# Capitol Expressway Corridor

## Final Environmental Impact Report

### Volume II Comments Received on Draft EIS/EIR and Responses to Comments

April 2005

CALTRAIN CAPITOL STATION LAYOUT FOR RELOCATION  
 (LOOKING SOUTH)  
 NO SCALE

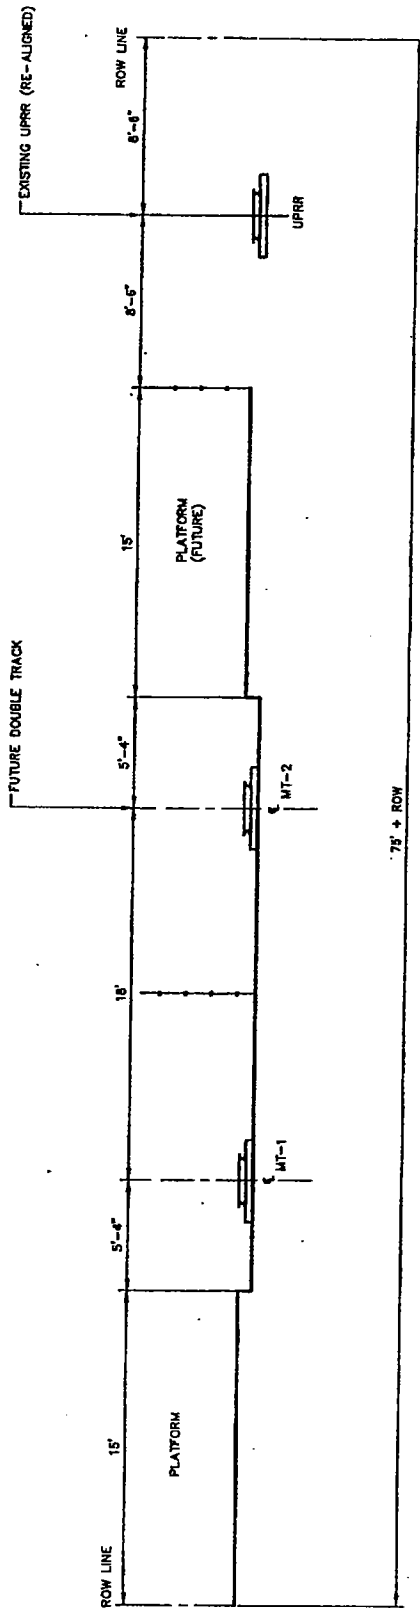
- 2. Page 3-21 and 3-22, Chapter 3.0. Alternatives Considered, Monterey Highway Station; Figure A-26– The existing Capitol Caltrain station that is proposed to be relocated shall be designed to allow future electrification, Caltrain double tracks, station outboard platforms and a grade separated pedestrian crossing. The station platform shall be 700' long per Caltrain Standards. L4-2

Figure A-2  
Light Rail Alternative Alignment

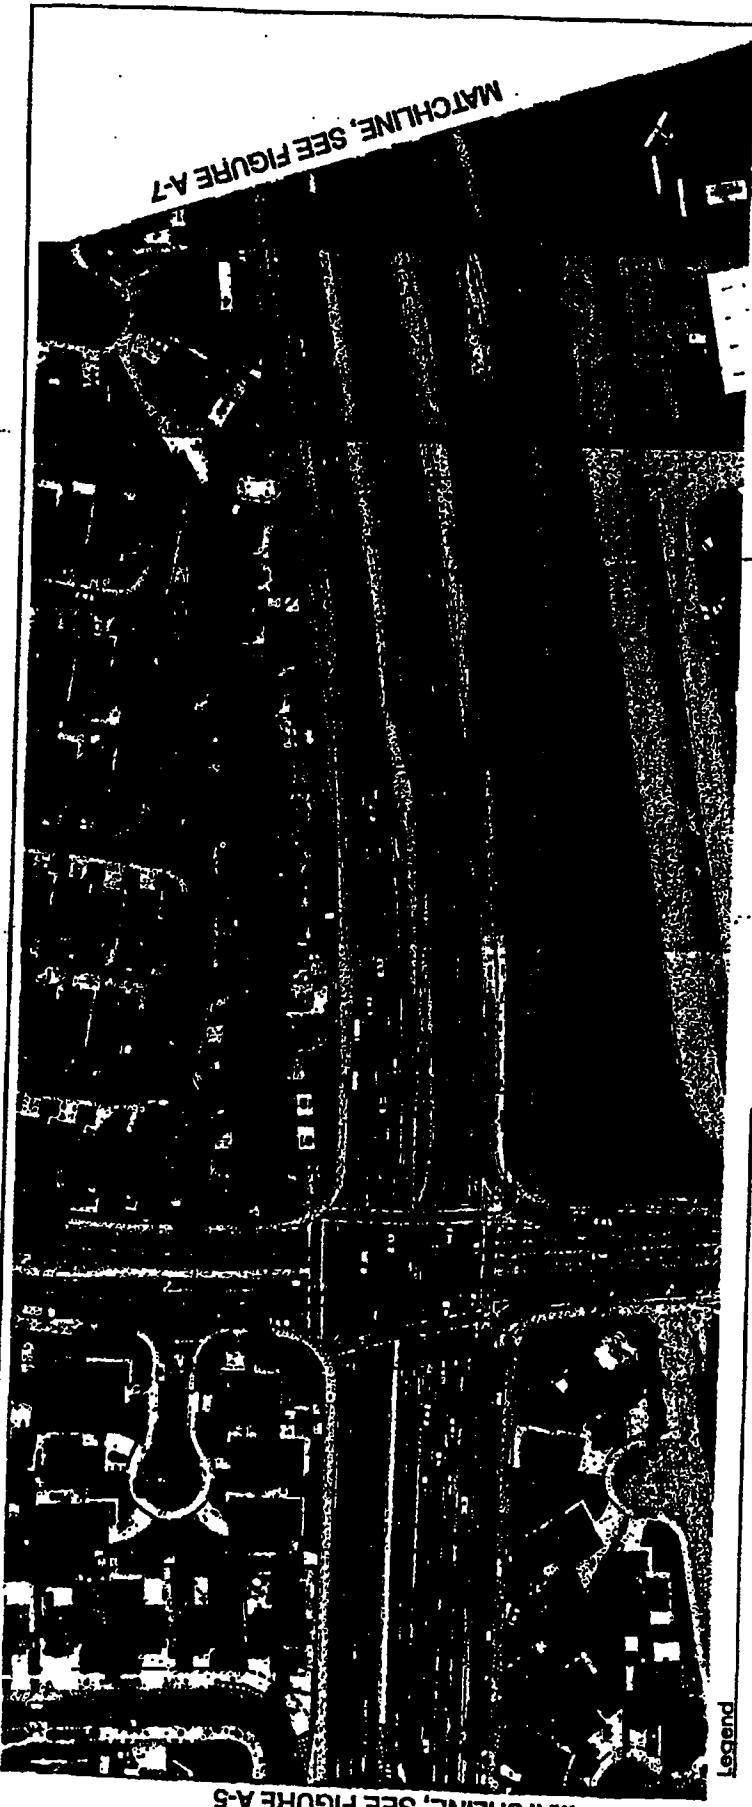
| 37 | 1. Figure A-2:      | The outer lane should be minimum 16 feet(TYP)   | L6-37 |
